Final Value Engineering Study Report

Monterey Peninsula Water Supply Project Desalination Plant

August 2014

Subject: Final Value Engineering Study Report
Monterey Peninsula Water Supply Project – Desalination Plant

VE ALTERNATIVE BD-1

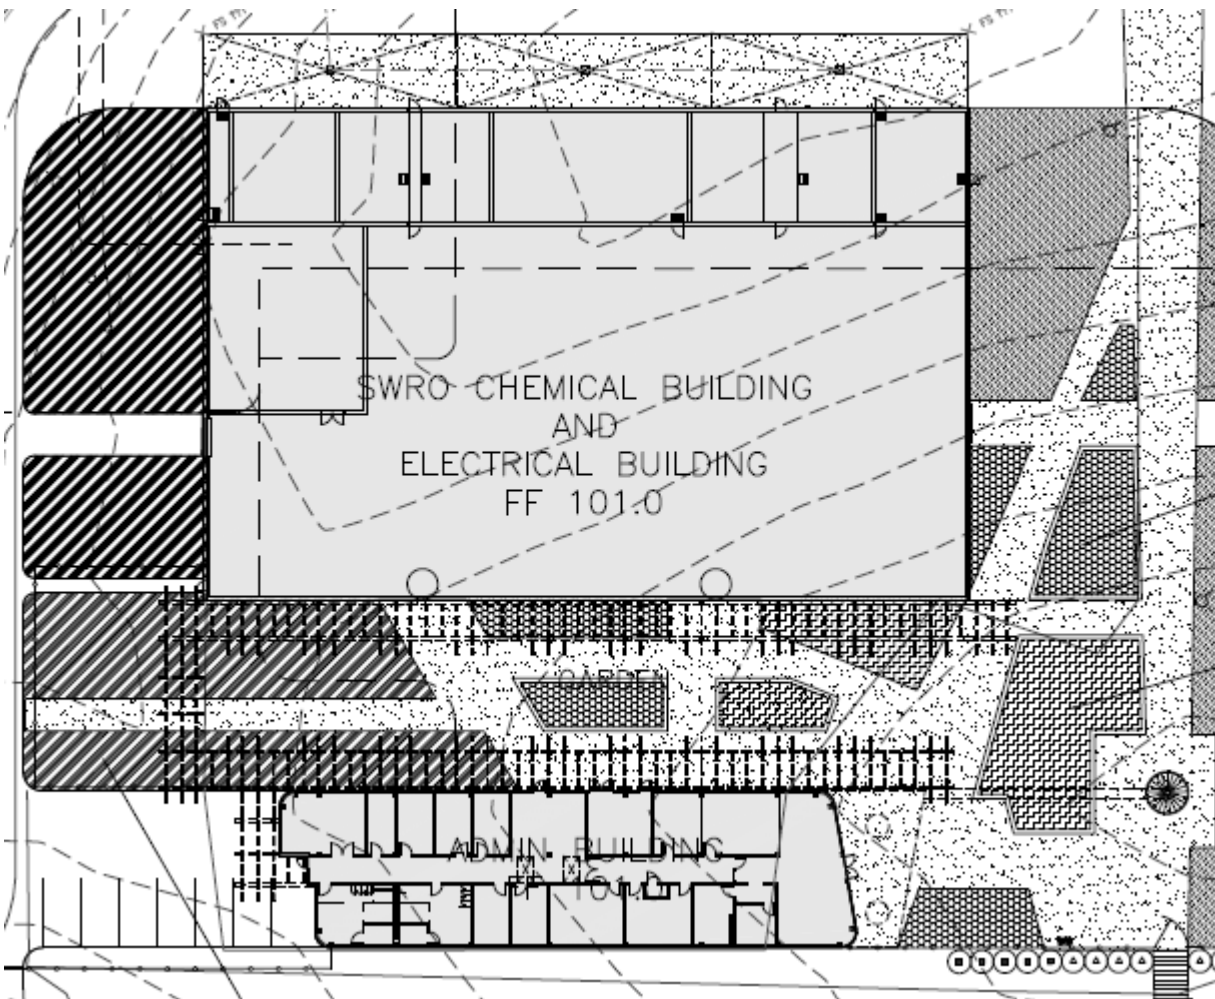
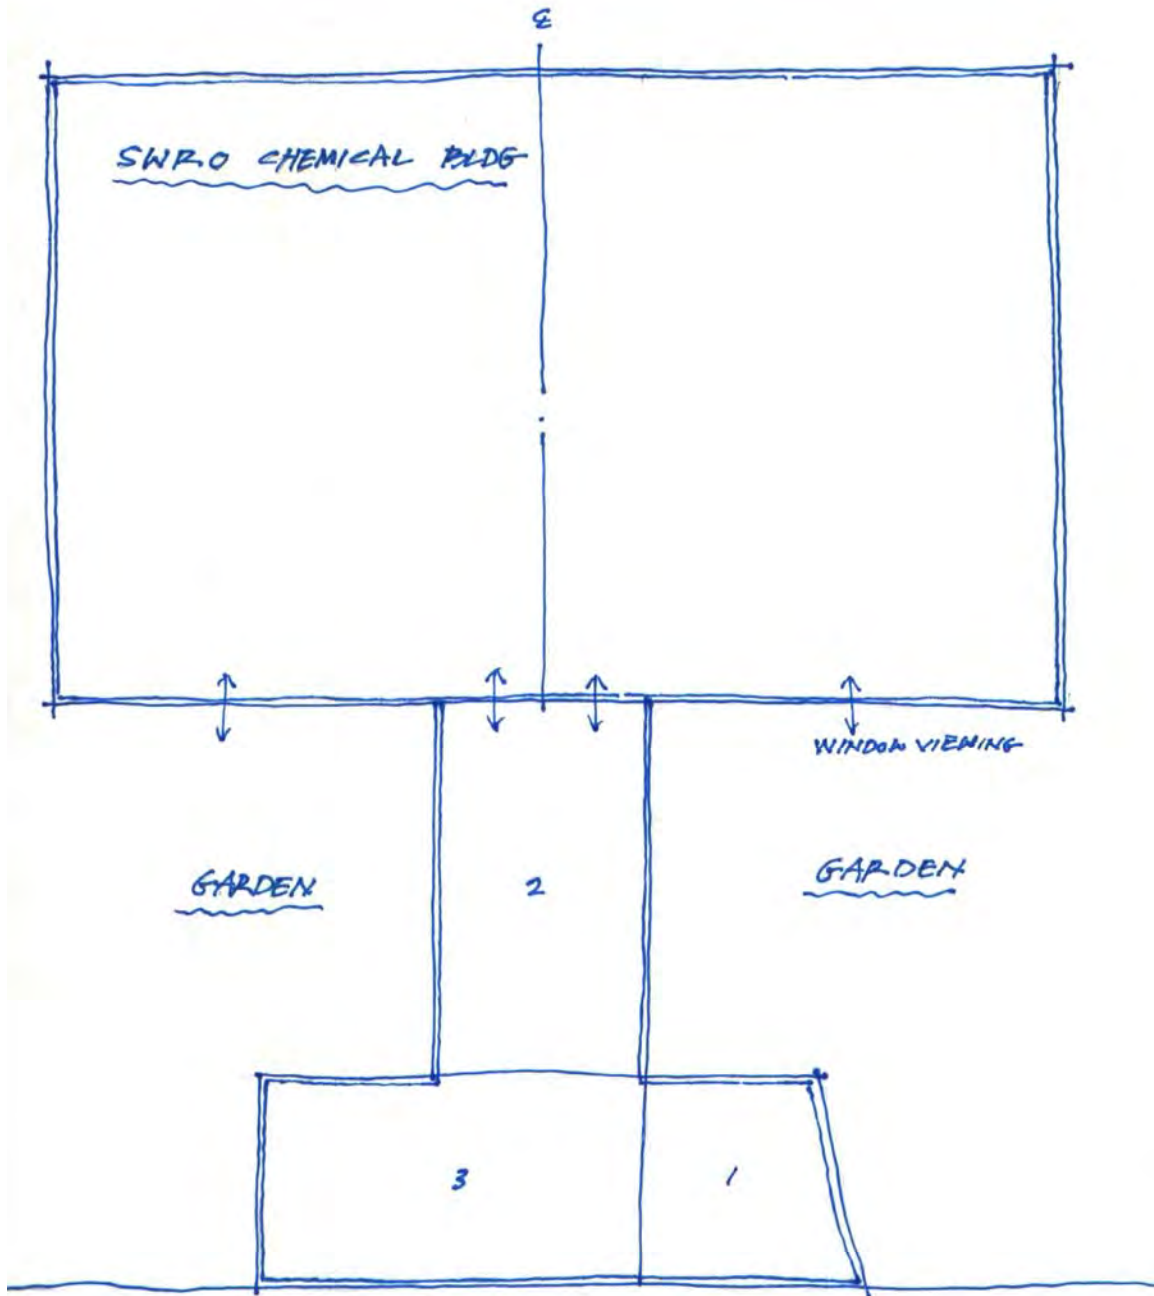
Description of Baseline Concept: The plan layout of the SWRO Building and Admin Building indicates two buildings separated by a 50-foot-wide open Garden space.

Description of Alternative Concept: The alternate concept attaches the Admin Building to the SWRO building in order to provide visual and direct physical connectivity from the Control Room, located inside the Admin Building, into the SWRO Building. The Control Room can either be one or two stories depending on whether or not visual connection is desired from a higher vantage point.

Discussion: Comments were voiced during the VE Workshop regarding (1) the possibility of reducing the 50-foot separation between the SWRO and Admin Buildings, and (2) a concern that the operators inside the Control Room will have no direct visual overview of the SWRO operations area. Also, experts on the VE Team reported that similar facilities often include control rooms with windows to allow direct visual overview of the operations plants. If a one story Admin Building plan is desired, the changes to accommodate the alternate plan will not be extensive. Plan changes will be slightly more extensive if a 2-story Control Room is selected.

VE ALTERNATIVE BD-4

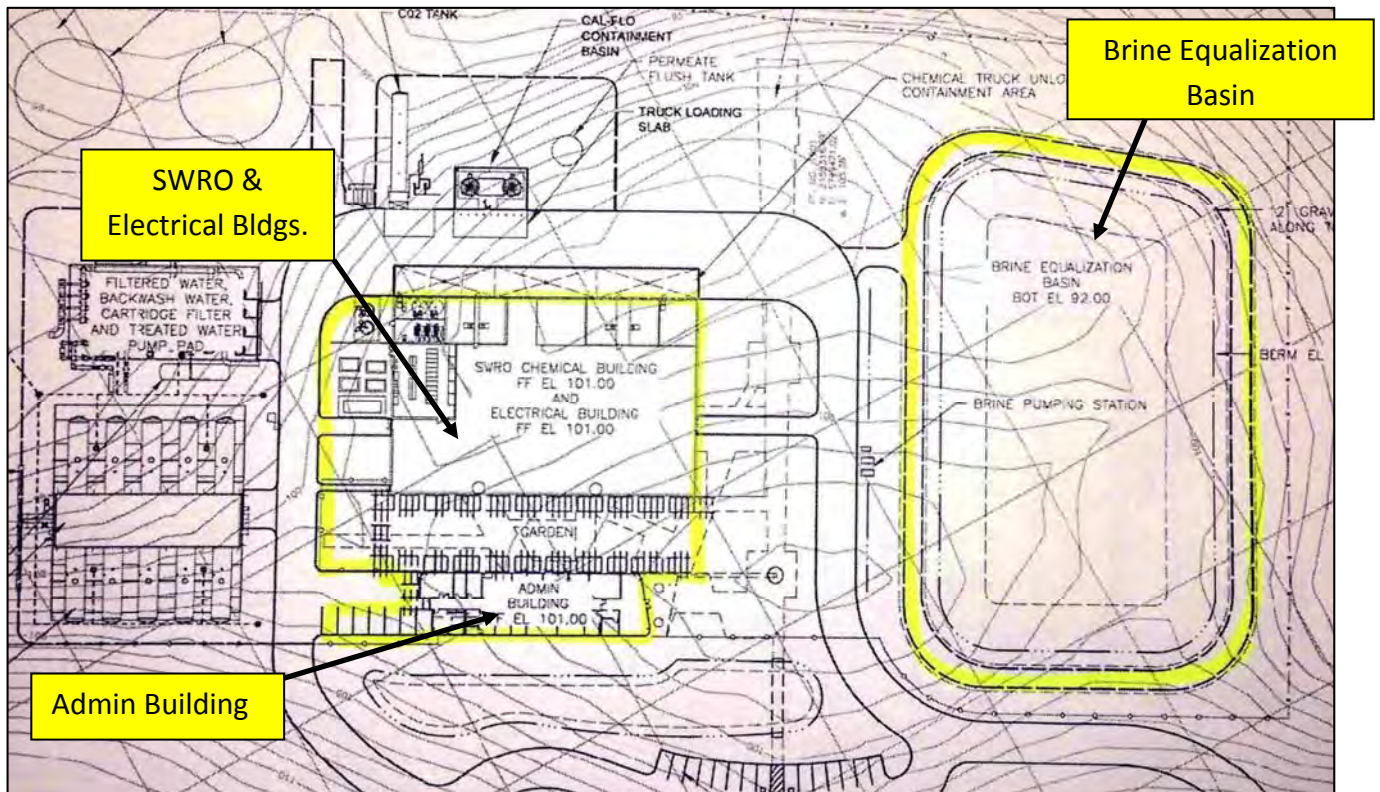
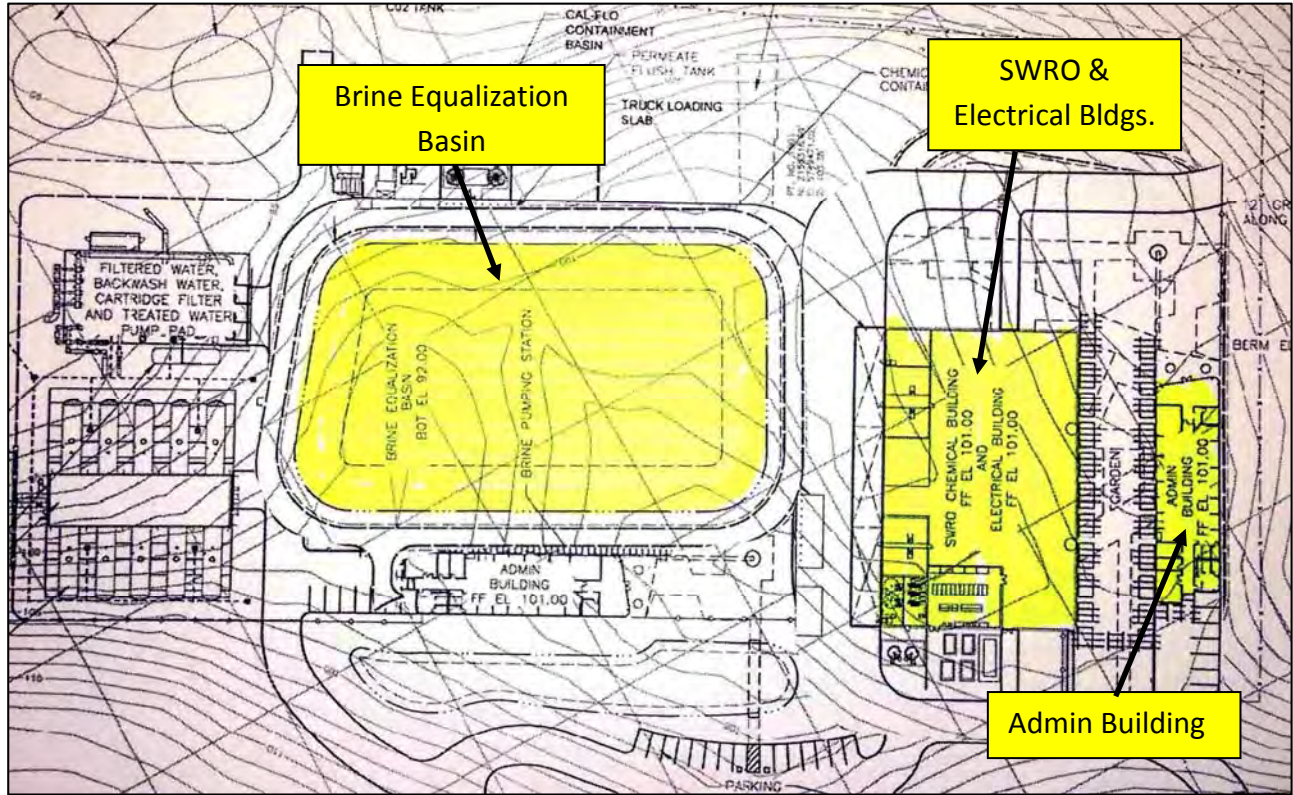
Shift site layouts to avoid collapsible soils

Proposed revised locations of plant facilities

VE ALTERNATIVE E-4

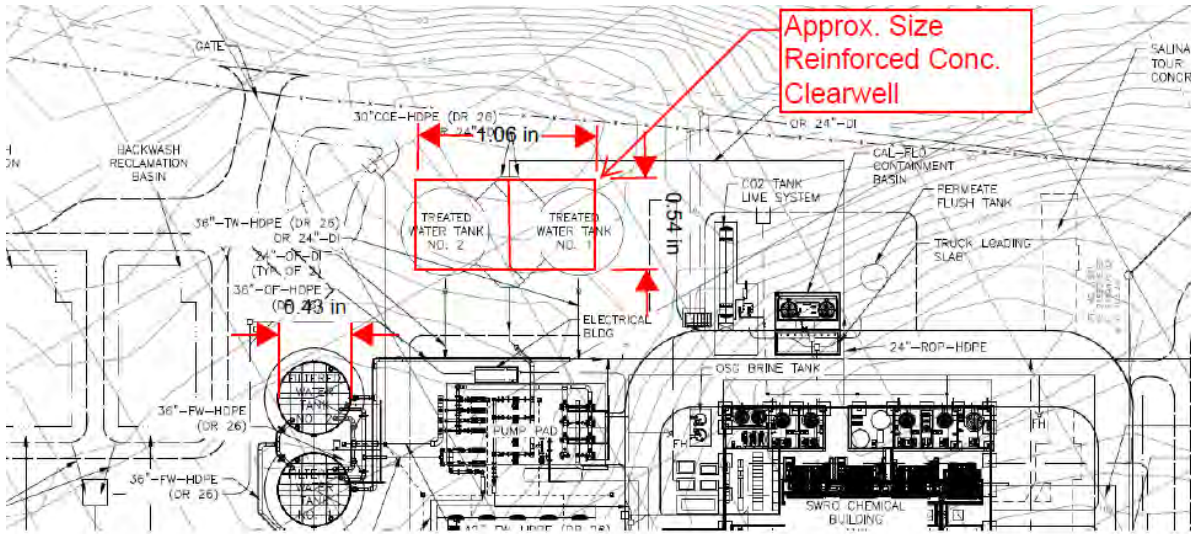
Construct the filtered water storage tanks out of concrete and construct as rectangular

VE ALTERNATIVE TP-2

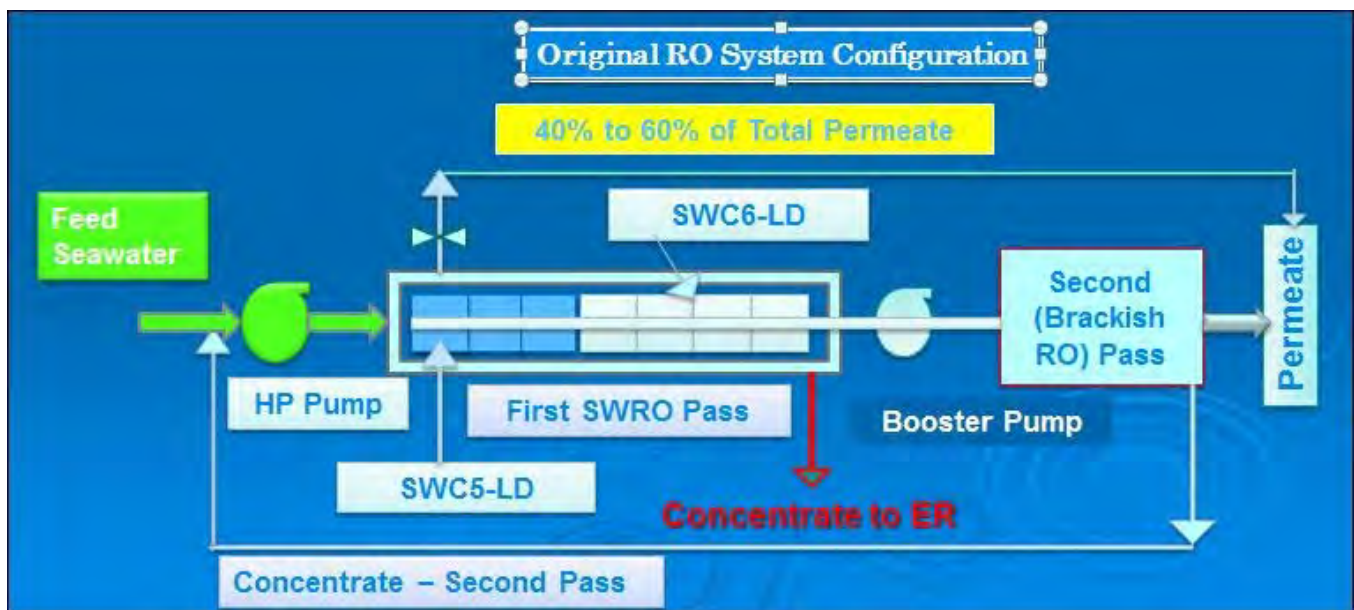
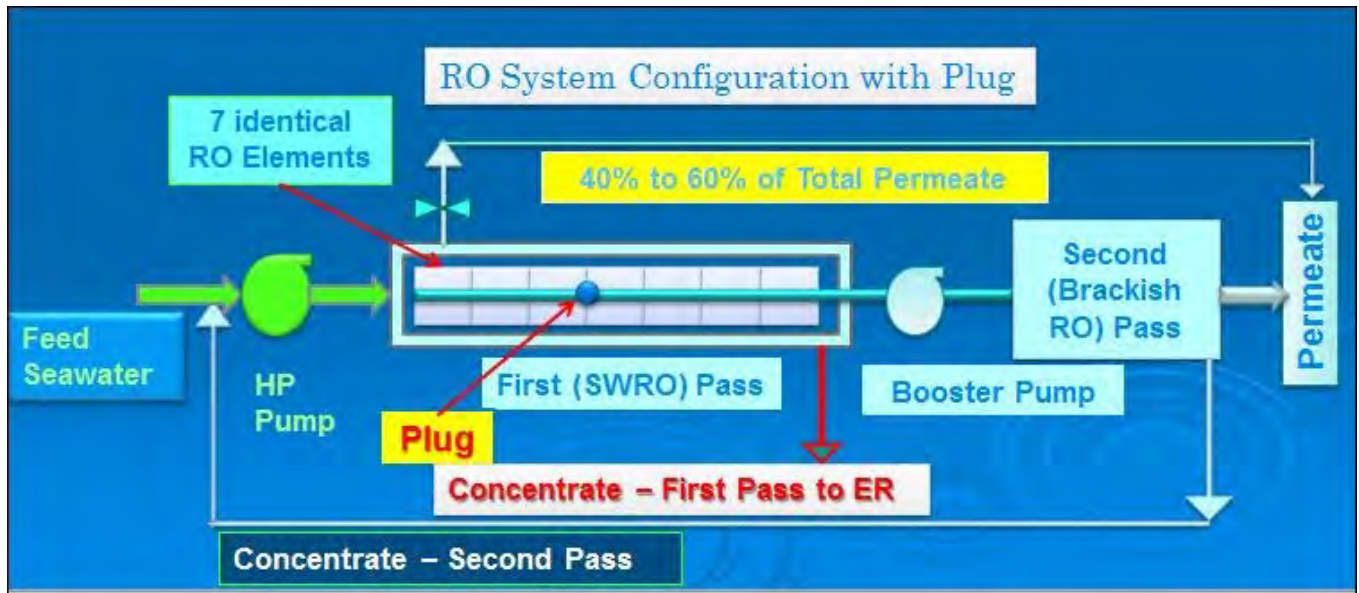
Install a plug on the main permeate line after the second or third membrane and use all of the same elements

Assumptions and Calculations: CIP cleaning frequency reduced from 4 times per RO train per year to 3 times per RO train per year.

VE ALTERNATIVE TP-3

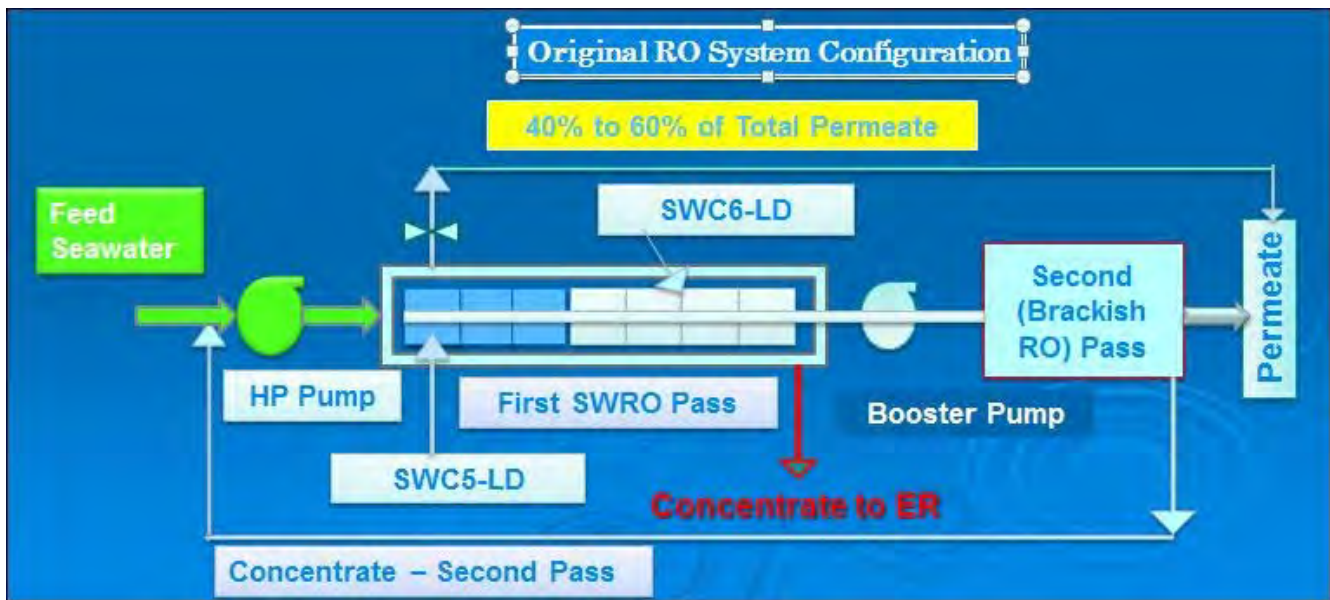
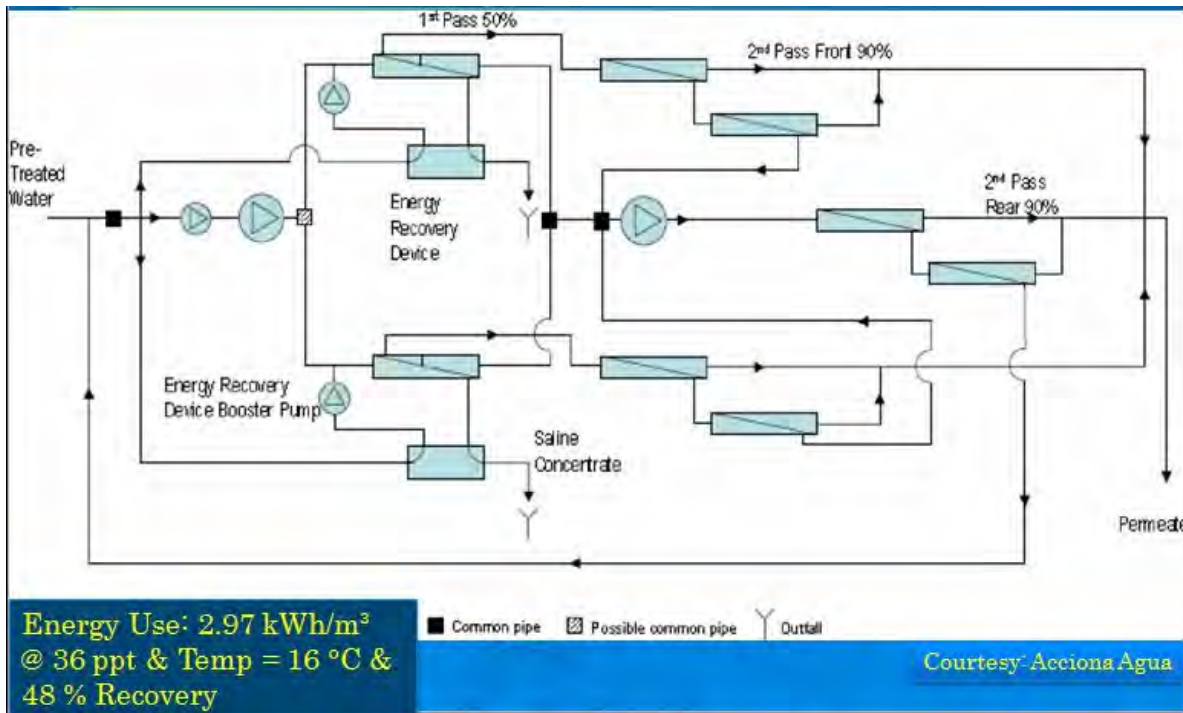
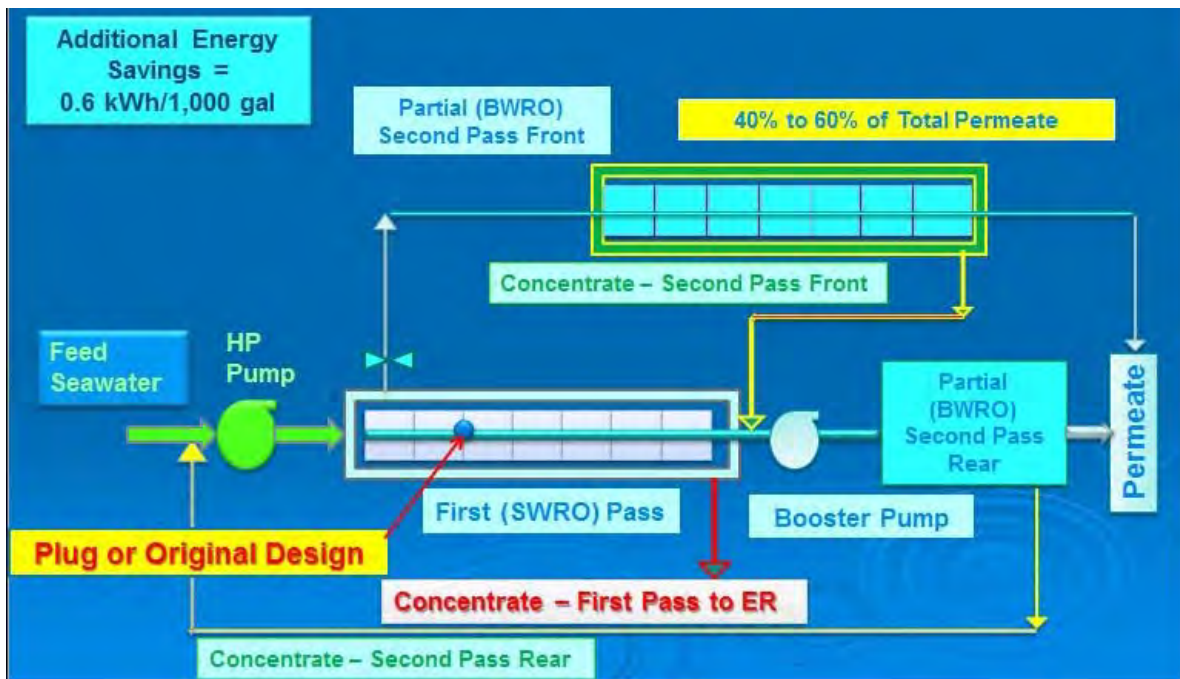
Install a second pass brackish RO train on the split stream to improve water quality and reduce energy use

VE ALTERNATIVE TP-8

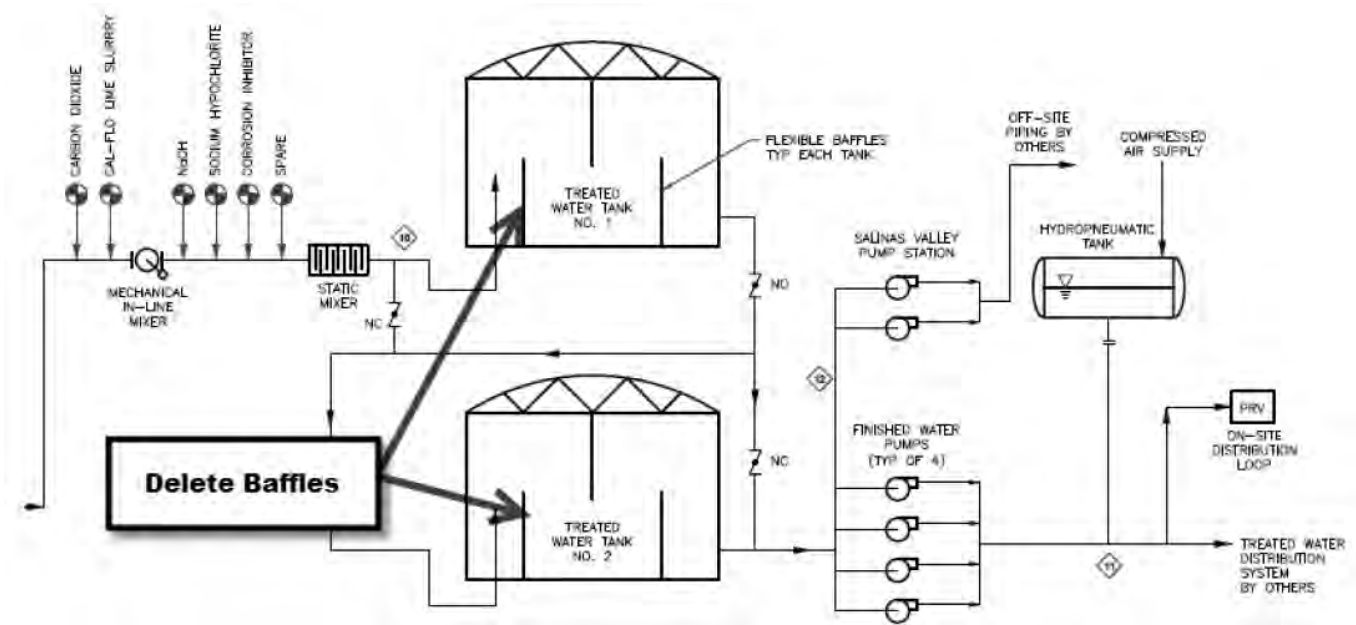
Eliminate baffles in the treated water storage tanks; obtain CT points elsewhere
